APPLICATION NO.	FILING DATE	FIRST NAMED INVENTOR	ATTORNEY DOCKET NO.	CONFIRMATION NO.
10/541,035	06/28/2005	Toshio Kumagai	Q88236	4010
23373 7590 09/11/2007 SUGHRUE MION, PLLC 2100 PENNSYLVANIA AVENUE, N.W. SUITE 800 WASHINGTON, DC 20037			EXAMINER	
			STEVENOSKY, MARK J	
			ART UNIT	PAPER NUMBER
,,,,,,,,,,,,,,,,,,,,,,,,,,,,,,,,,,,,,,,	.,, _ 0 _ 0 0 0 0		2853	
•			MAIL DATE	DELIVERY MODE
			09/11/2007	PAPER

•		•				
	Application No.	Applicant(s)				
	10/541,035	KUMAGAI ET AL.				
Office Action Summary	Examiner	Art Unit				
	Mark John Stevenosky, Jr.	2853				
The MAILING DATE of this communication app Period for Reply	pears on the cover sheet with the c	correspondence address				
A SHORTENED STATUTORY PERIOD FOR REPL' WHICHEVER IS LONGER, FROM THE MAILING D. Extensions of time may be available under the provisions of 37 CFR 1.1 after SIX (6) MONTHS from the mailing date of this communication. If NO period for reply is specified above, the maximum statutory period of Failure to reply within the set or extended period for reply will, by statute Any reply received by the Office later than three months after the mailing earned patent term adjustment. See 37 CFR 1.704(b).	ATE OF THIS CO

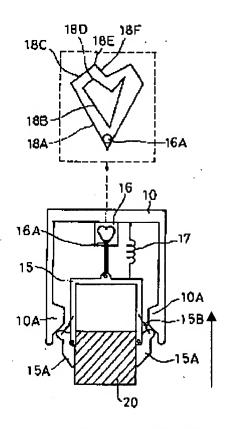
- the slide member slides along an insertion direction [guide 16A slides in a direction with at least some component in the direction of the direction in which cartridge 20 is being slid] of the liquid cartridge between a first position and a second position [the position displayed in Figure 2 will be considered the first position, and while any of the positions displayed in any of Figures 3, 4 or 5 could be regarded as the second position, examiner is choosing the position displayed in Figure 4 as the second position], and

- the insertion direction is a direction in which the liquid cartridge is inserted into the cartridge holder when the liquid cartridge is attached to the cartridge holder [the direction of insertion is indicated by the arrow provided by examiner below], and

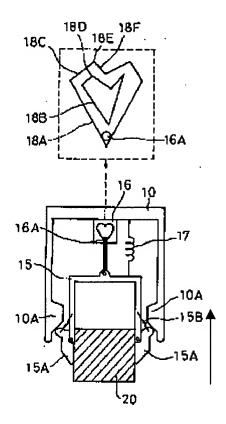
- the slide member slides along an insertion direction [guide 16A slides in a direction with at least some component in the direction of the direction in which cartridge 20 is being slid] of the liquid cartridge between a first position and a second position [the position displayed in Figure 2 will be considered the first position, and while any of the positions displayed in any of Figures 3, 4 or 5 could be regarded as the second position, examiner is choosing the position displayed in Figure 4 as the second position], and

- the insertion direction is a direction in which the liquid cartridge is inserted into the cartridge holder when the liquid cartridge is attached to the cartridge holder [the direction of insertion is indicated by the arrow provided by examiner below], and
